From: Alistair Osborne [REDACTED]
Sent: Friday, 25 September 2026 4:45 pm
To: Miguel Hernandez; Kyle Dirse
Cc: land.development; Torrey McDonnell; Zeean Brydon
Subject: RE: Mt Welcome - Updated Flood Modelling - TW Queries 10.09.26 [Filed 04 Oct 2026 21:09]

Depth Difference Maps – 100yr+CC scenario

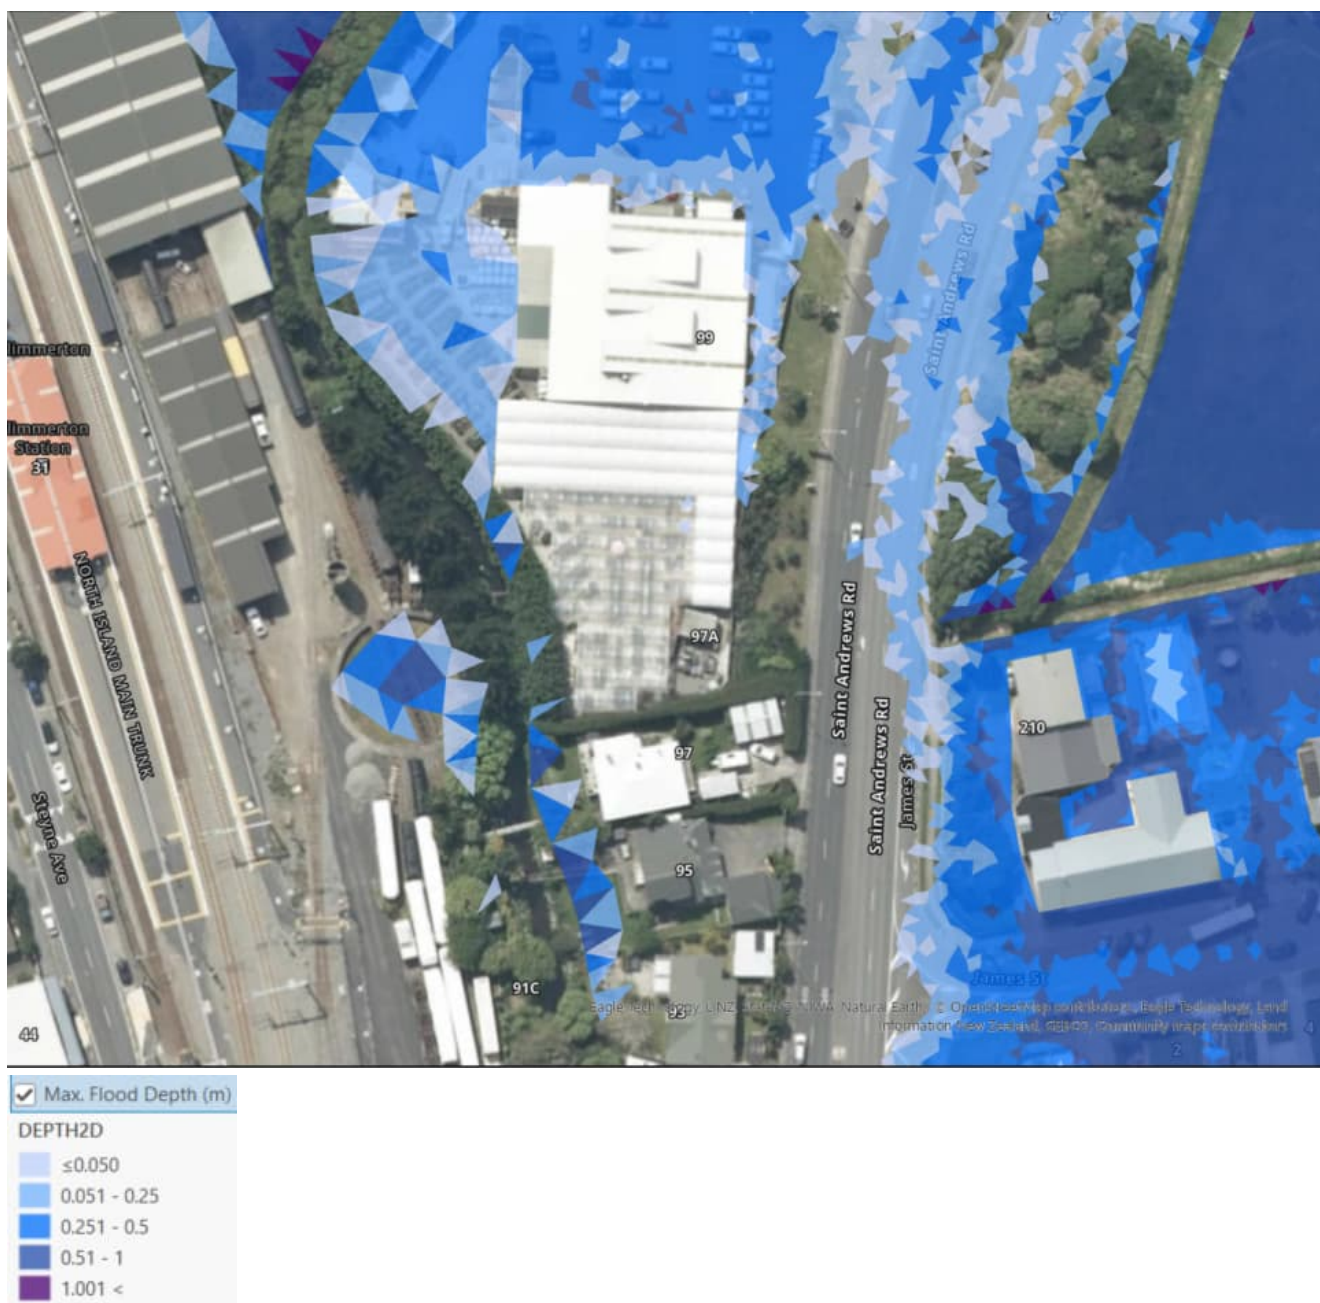
This made the flood depth comparison between the pre and post scenarios very straight forward. The results are shown below. Based on these results I am comfortable with the Envelope conclusion that the effects of the development (as represented in the modelling Envelope supplied on 21/09/26) on flooding in Plimmerton are less than minor. While the flooding does change in the post development scenario, it is primarily by an increase of less than 0.05m, or by a decrease. There is one location where there is an increase of greater than 0.05m. This location is on the southside of the Palmers Garden Centre property. The change varies across the location with very localised areas of increase (see below).

I also tested the possibility of instability in the model simulation impacting the results by running the pre and post scenario simulations a second time and then re-doing the depth difference assessment. This generates slightly different results, which indicates model instability can slight changes in model output.

Depth difference has been calculated by subtracting the pre-development flood depths from the post development flood depths. I have also provided the pre development flood depths to give an indication of the flood depth impacted by the change.

The two images below show the impact of model instability on the results, there are some small, localised changes in the calculated depth difference, indicating different slightly depth results from identical model runs at those locations.
